Access Compliance Report

Public Rights-of-Way

Intersection ID: 10029589	Main Street: KILSYTH_ST	Cross Street: N/A	Location: SW
ADA ID: 756F2BFF046F	Ramp Type: Perp	Initial Pass/Fail: Fail	Overall Compliance: No
Severity Score: 13.75			
Codes/Mitigation Info/Possible Solution		Field Measurements/Component Compliance

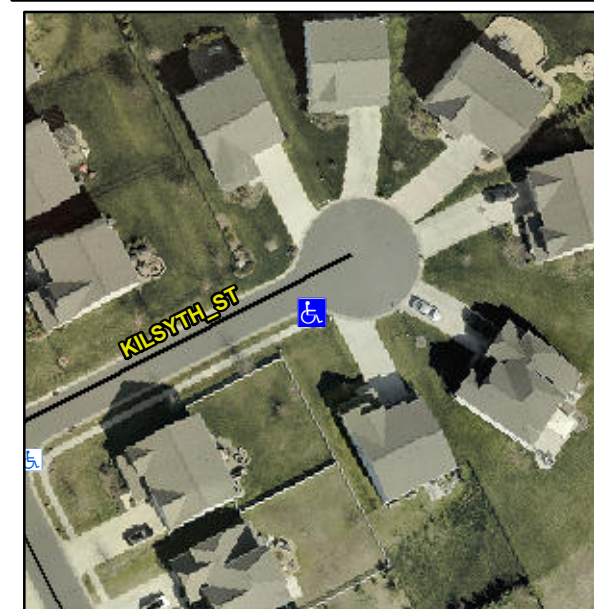
Compliance	Description	Data	Compliance	Description	Data
N/A	Ramp Length (in)	49.0	No	Ramp Slope (%)	9.3
Yes	Ramp Width (in)	48.0	No	Ramp XSlope (%)	2.1
N/A	Flare Type LT	N/A	N/A	Flare Type RT	N/A
N/A	Flare Slope LT (%)	N/A	N/A	Flare Slope RT (%)	N/A
N/A	Flare Traversable LT?	N/A	N/A	Flare Traversable RT?	N/A
N/A	Landing Length (in)	N/A	N/A	DWS Provided?	N/A
N/A	Landing Width (in)	N/A	N/A	DWS Contrast?	N/A
N/A	Landing Slope (%)	N/A	N/A	DWS Length (in)	N/A
N/A	Landing X Slope (%)	N/A	N/A	DWS Full Width?	N/A
N/A	Landing Curb? (Y/N)	N/A	N/A	DWS Offset (in)	N/A
N/A	Shared Landing?	N/A			
N/A	Gutter Ponding?	N/A	N/A	Gutter Slope (%)	N/A
N/A	Gutter Lip Ht (in)	N/A	N/A	Gutter X Slope (%)	N/A
N/A	Painted X Walk1?	No	N/A	Painted X Walk2?	N/A
	X Walk 1 Direction	To NW		X Walk 2 Direction	N/A
N/A	X Walk 1 Width (in)	N/A	N/A	X Walk 2 Width (in)	N/A
	X Walk 1 Slope (%)	4.0		X Walk 2 Slope (%)	N/A
	X Walk 1 X Slope (%)	0.8		X Walk 2 X Slope (%)	N/A

Remove & Replace Entire Ramp.

R304.2.2, R304.5.3
